Office Action Summary	Application No.	Applicant(s)	
	10/772,481	COXON ET AL.	
	Examiner	Art Unit	
	Rodney H. Bonck	3681

DETAILED ACTION

The following action is in response to the amendment received March 16, 2006.

FIG 1

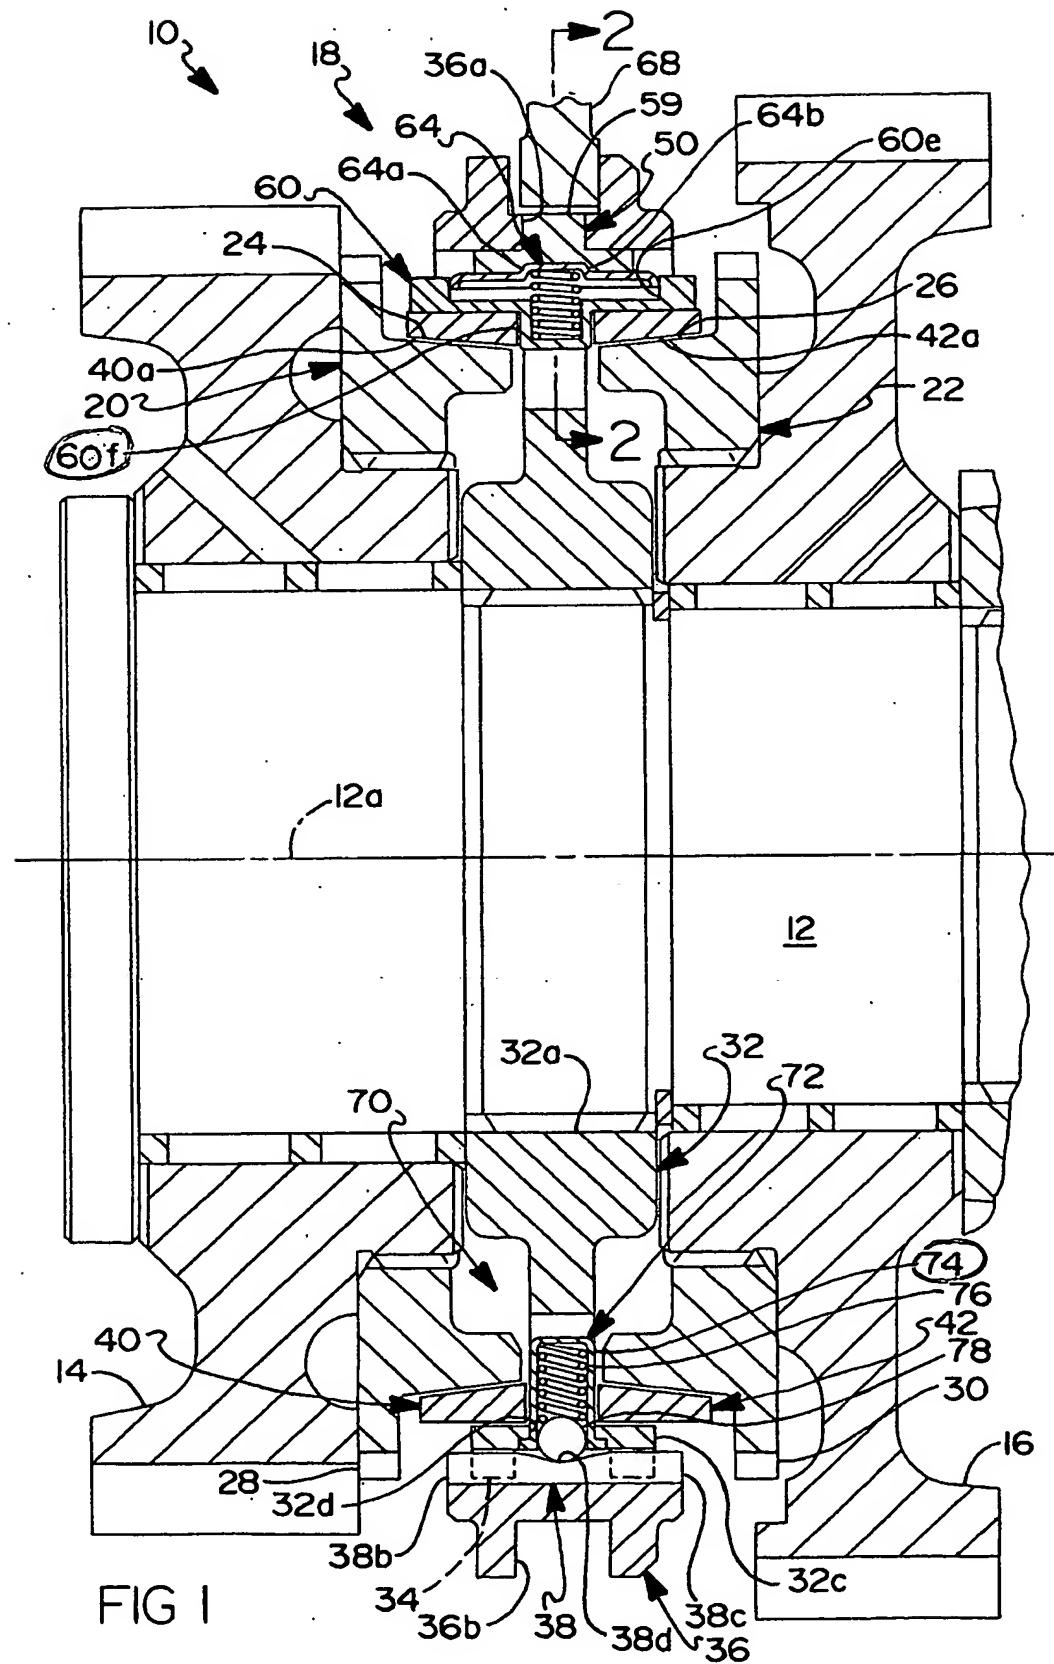
The replacement sheet of drawings and the annotated sheet of drawing showing proposed changes were received on March 16, 2006. These proposed changes and the replacement sheets of drawings are approved by the examiner.

Approved
RTH
M 18/06
